## Relevant Information for Local Planning Panel

**FILE:** D/2020/55 **DATE:** 2 September 2020

**SUBJECT:** Information Relevant To Item 3 – Development Application: 29-41 Hutchinson Street, Surry Hills – D/2020/55

**Figure 1:** View from rear of No. 16 Nichols Street.

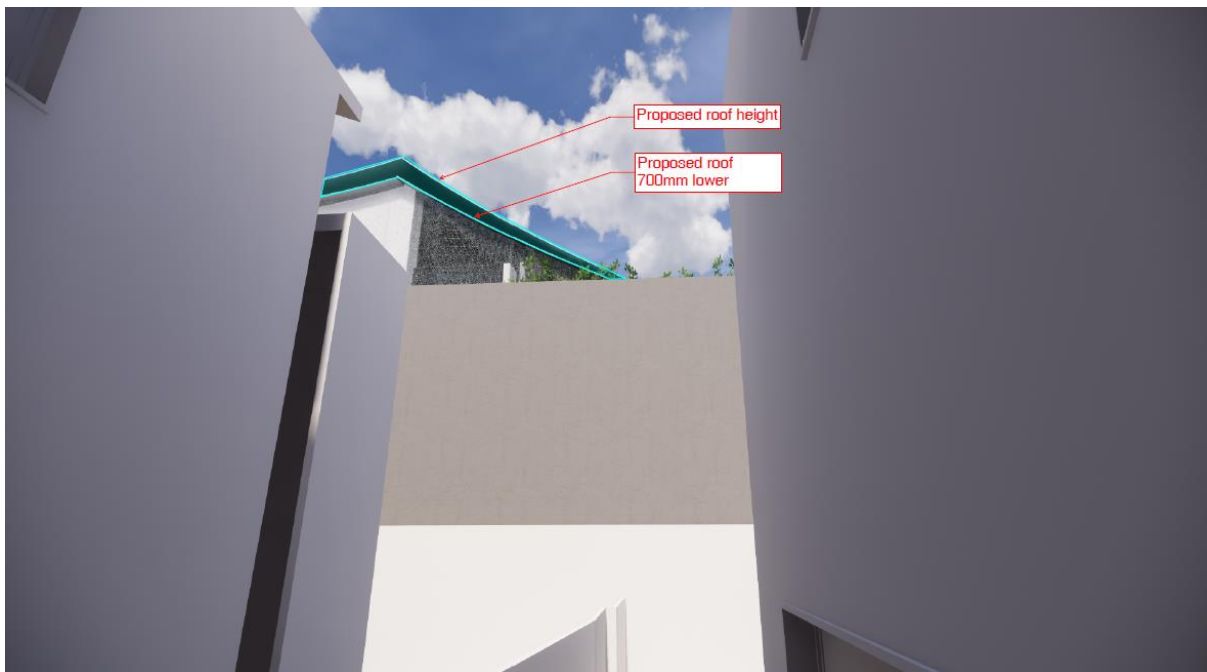
As part of the assessment process the City requested options for lowering the roof pitch along the western boundary. The applicant provided a study for lowering of the maximum ridge height at the western boundary by 700mm. The image below shows a perspective view from the rears of No. 16 and 24 Nichols Street with a comparison between the proposed roof height and pitch lowered by 700mm.

The reduction in height would reduce usable office floor area and amenity. Given the minimal change to the perceived bulk achieved by the lowering of the roof it was not considered to be required.
